Access Compliance Report

Public Rights-of-Way

(Curb Ramps)

Intersection ID: 10027854	Main Street: HAMILTON_RD	Cross Street: N/A	Location: NE
ADA ID: 0BB628B8D936	Ramp Type: PerpDiag	Initial Pass/Fail: Fail	Overall Compliance: No
			Severity Score: 21.25

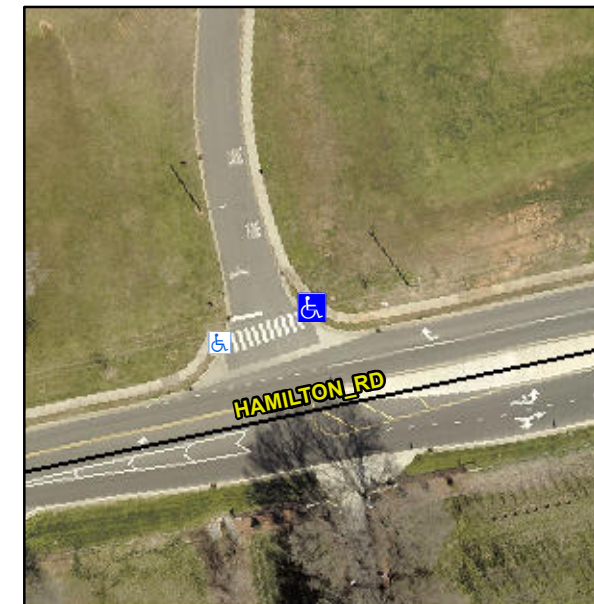
Not Found, R304.5.1, R304.2.2

Compliance	Description	Data	Compliance	Description	Data
N/A	Ramp Length (in)	47.0	No	Ramp Slope (%)	9.6
No	Ramp Width (in)	46.5	Yes	Ramp XSlope (%)	1.0
N/A	Flare Type LT	N/A	N/A	Flare Type RT	N/A
N/A	Flare Slope LT (%)	N/A	N/A	Flare Slope RT (%)	N/A
N/A	Flare Traversable LT?	N/A	N/A	Flare Traversable RT?	N/A
N/A	Landing Length (in)	N/A	N/A	DWS Provided?	N/A
N/A	Landing Width (in)	N/A	N/A	DWS Contrast?	N/A
N/A	Landing Slope (%)	N/A	N/A	DWS Length (in)	N/A
N/A	Landing X Slope (%)	N/A	N/A	DWS Full Width?	N/A
N/A	Landing Curb? (Y/N)	N/A	N/A	DWS Offset (in)	N/A
N/A	Shared Landing?	N/A			
N/A	Gutter Ponding?	N/A	N/A	Gutter Slope (%)	N/A
N/A	Gutter Lip Ht (in)	N/A	N/A	Gutter X Slope (%)	N/A
N/A	Painted X Walk1?	Yes	N/A	Painted X Walk2?	No
	X Walk 1 Direction	To W		X Walk 2 Direction	To S
N/A	X Walk 1 Width (in)	120.0	N/A	X Walk 2 Width (in)	N/A
	X Walk 1 Slope (%)	1.3		X Walk 2 Slope (%)	1.7
	X Walk 1 X Slope (%)	0.4		X Walk 2 X Slope (%)	1.8

Remove & Replace Curb Ramp With Two New Directional Ramps or Equivalent.
